23085 Fargo Public Library Sunshades Replacement

RE: Addendum #01

Issued: June 1, 2023

SHEET
A201
 FIRST FLOOR PLAN

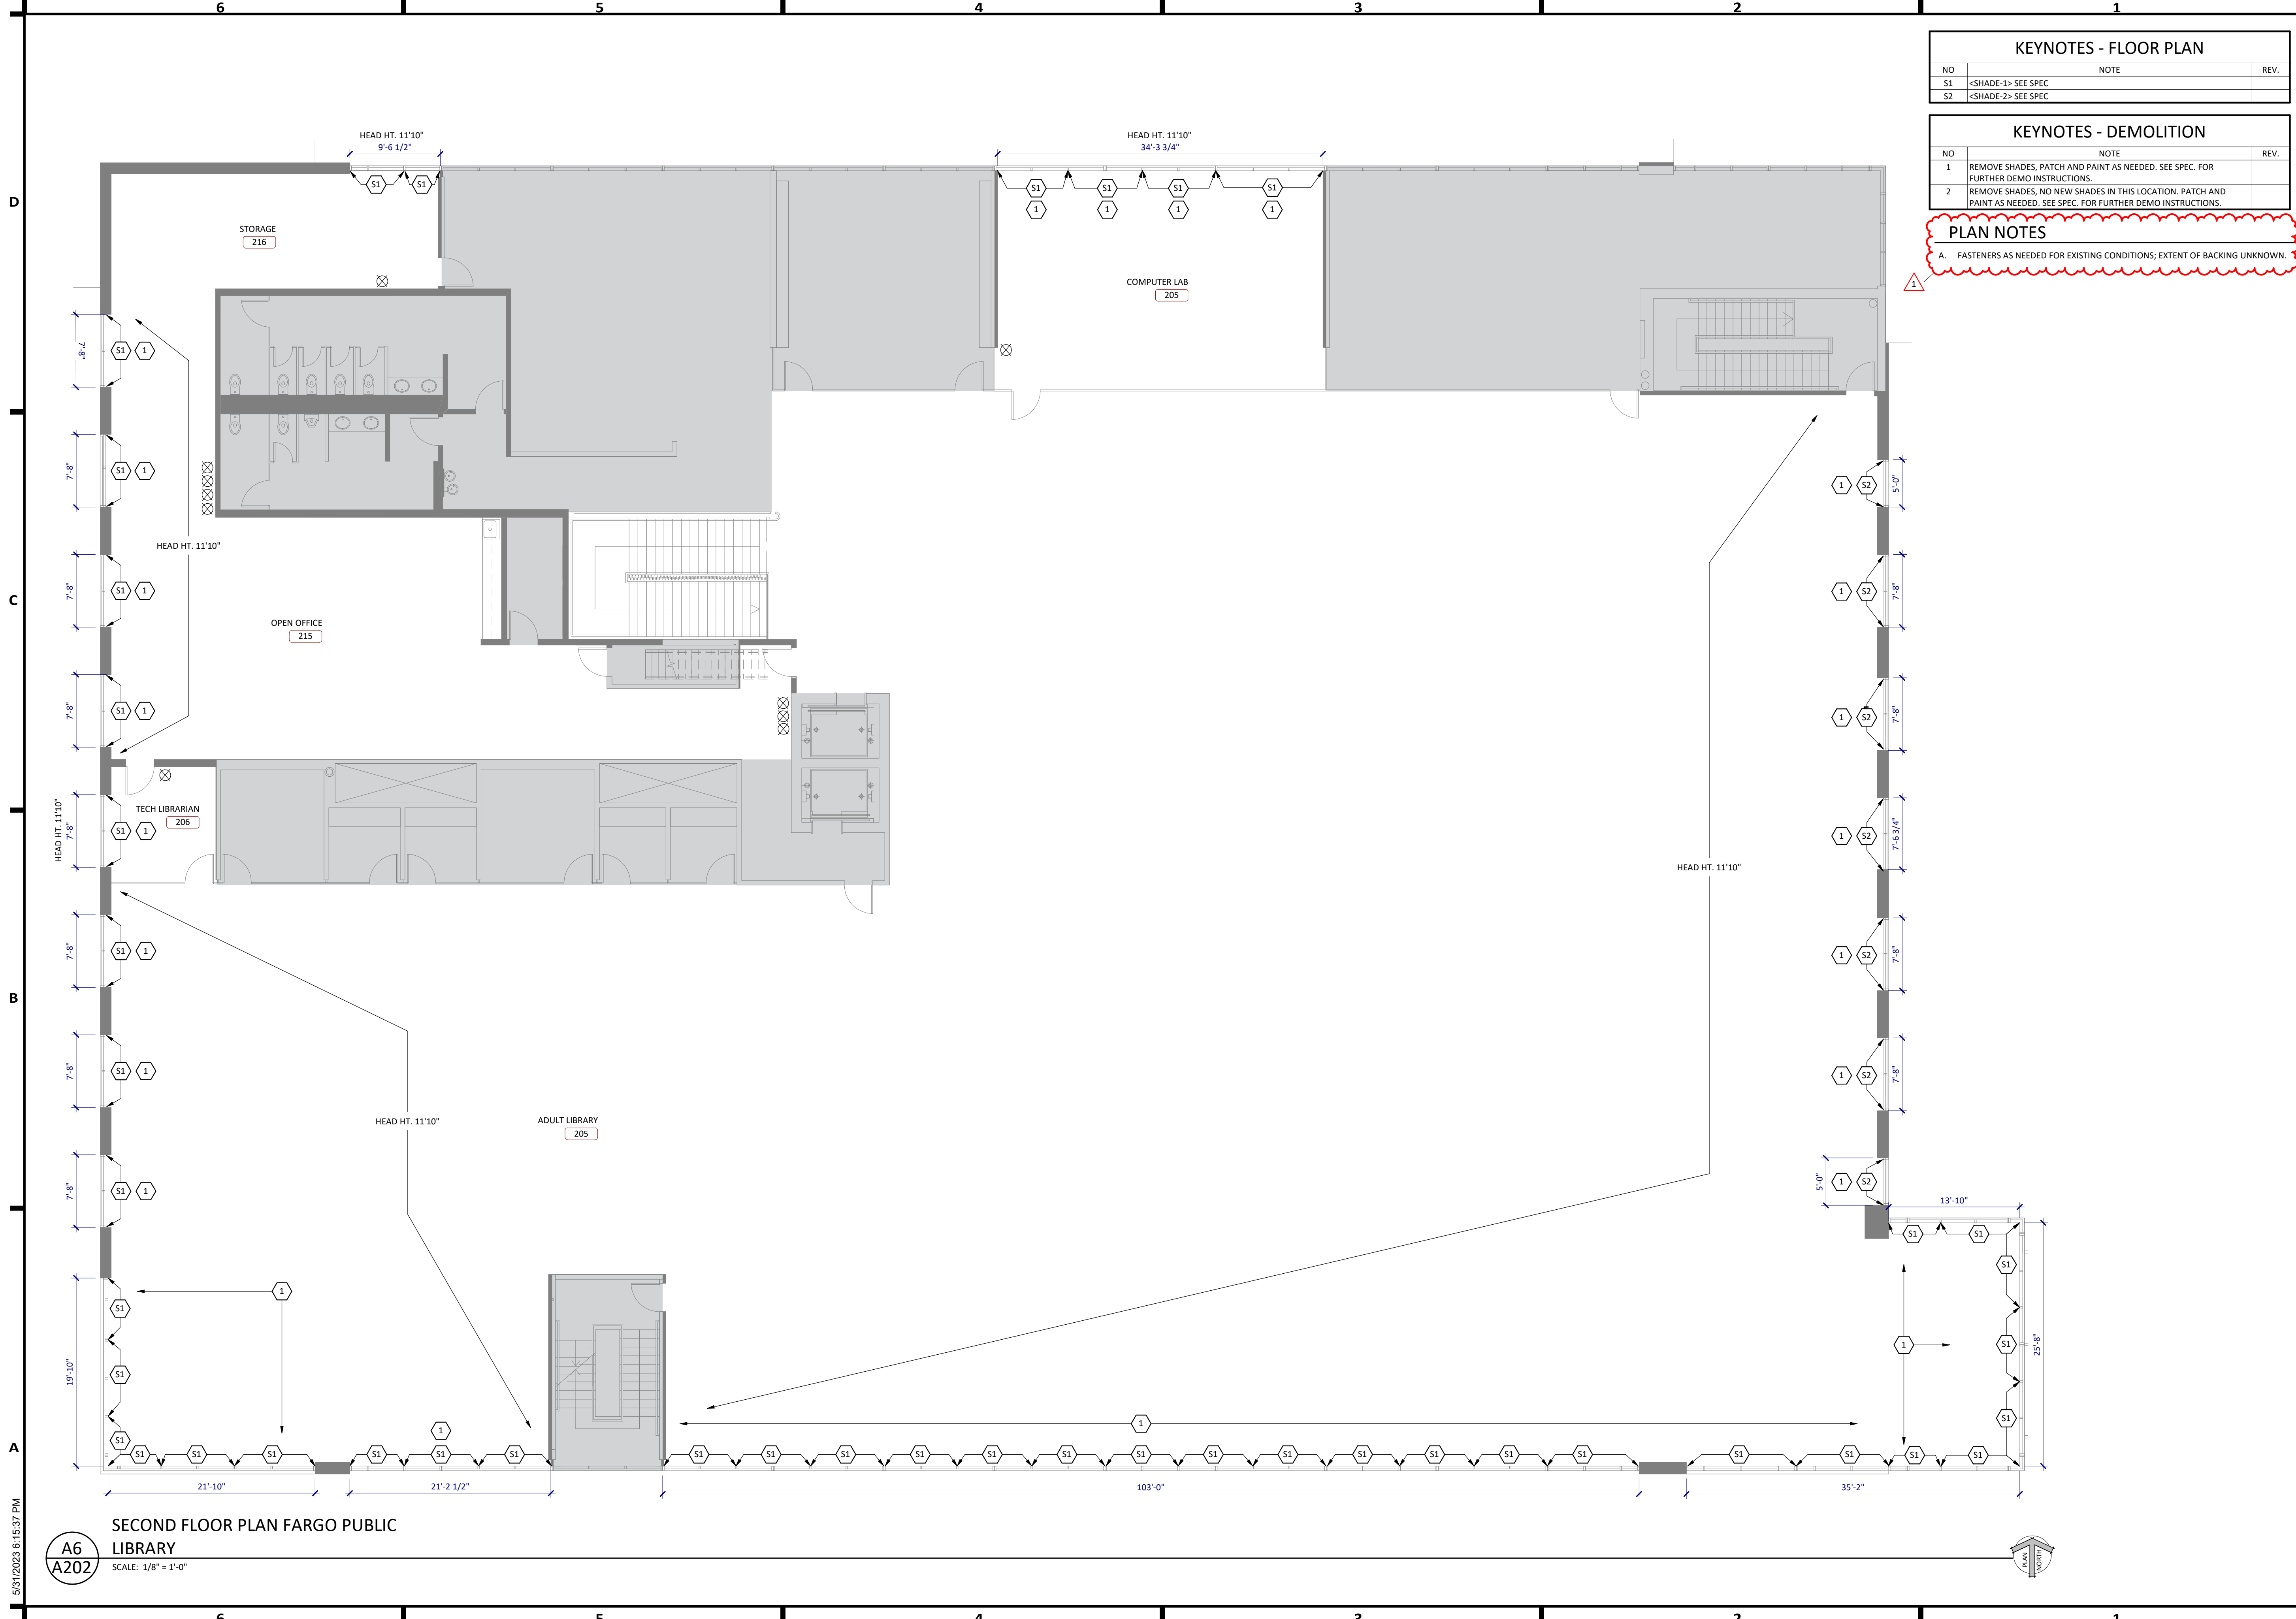
- o Replace Window Sunshade controls location text 6.ii. Controls located on north wall of door between Open Office 131 and Children’s Area 110. See attached revised drawings A201 and E200 for updated location.

- o Drawing A6/A201: Change the location of the shades operating controls for Children’s Area from Data 167 to the north wall of the door between Open Office 131 and Children’s Area 110.
- o Add “Plan Notes: Fasteners as needed for existing conditions. Extent of blocking unknown.”

SHEET
E200
FIRST FLOOR
ELECTRICAL PLAN

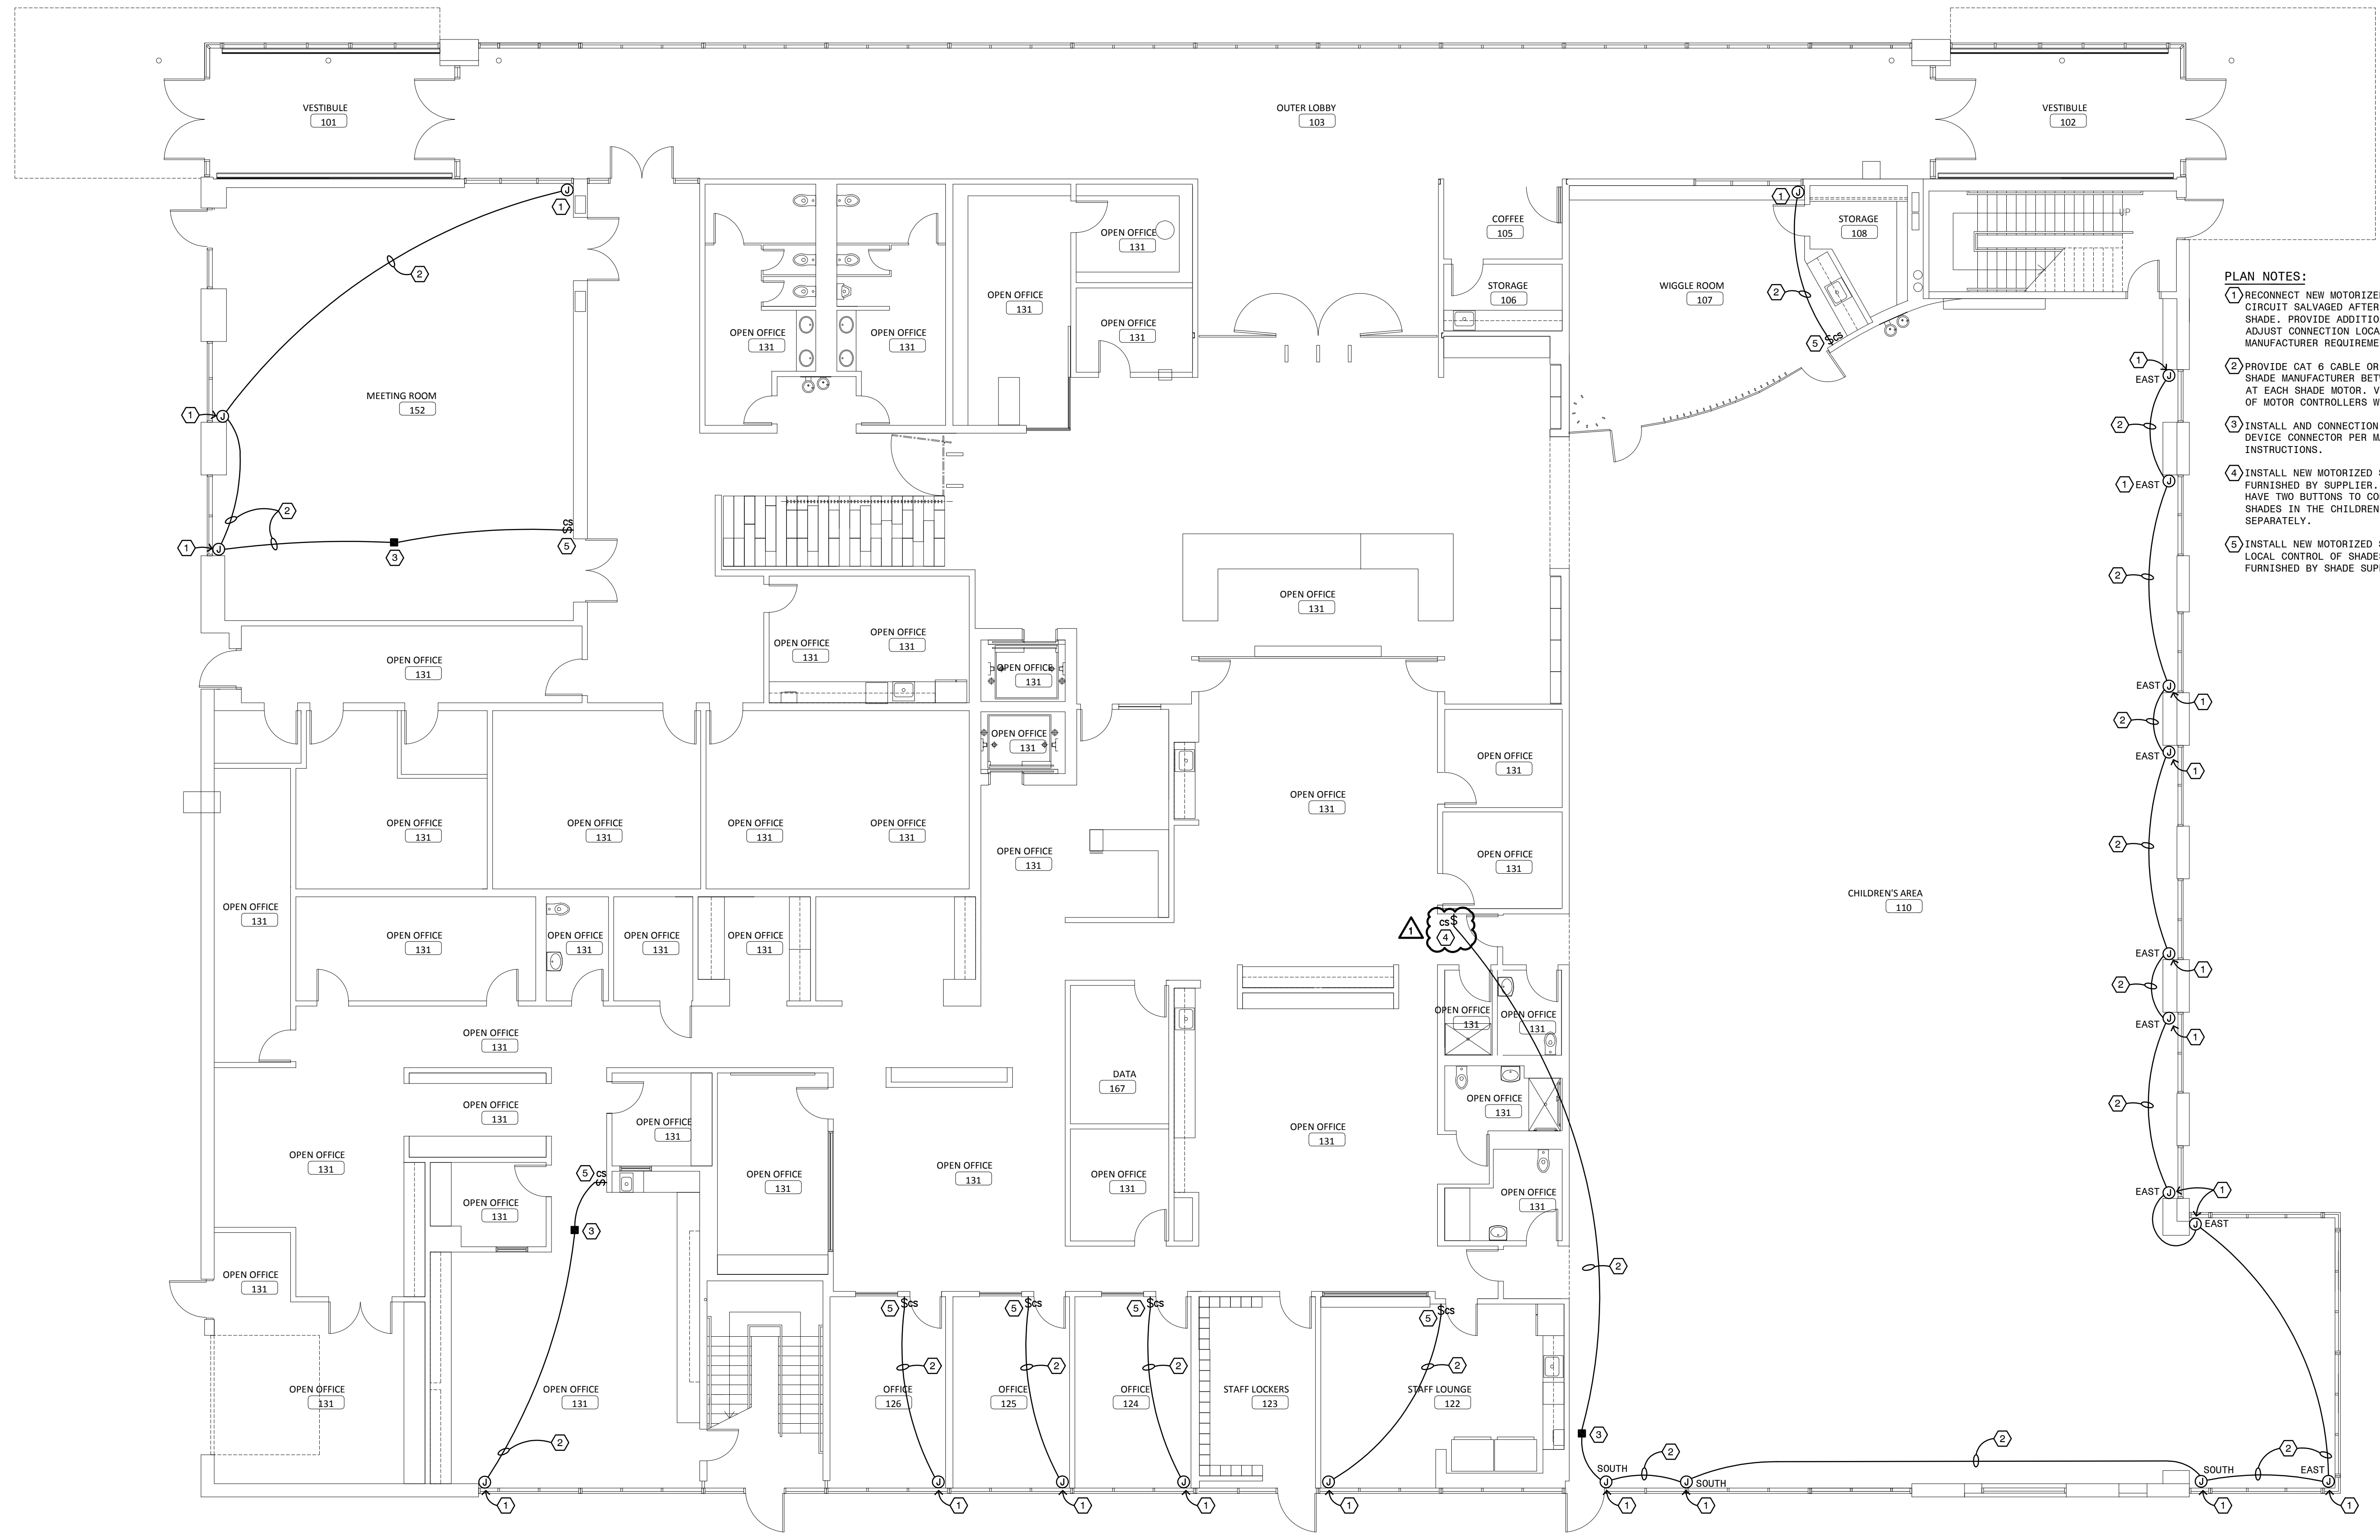
- The control station for children’s area 101 is to be relocated to room 131. Refer to Electrical Addendum #01 items.

1. The control station for children's area 110 is to be relocated to room 131. See attached revised drawing E200 for updated location.
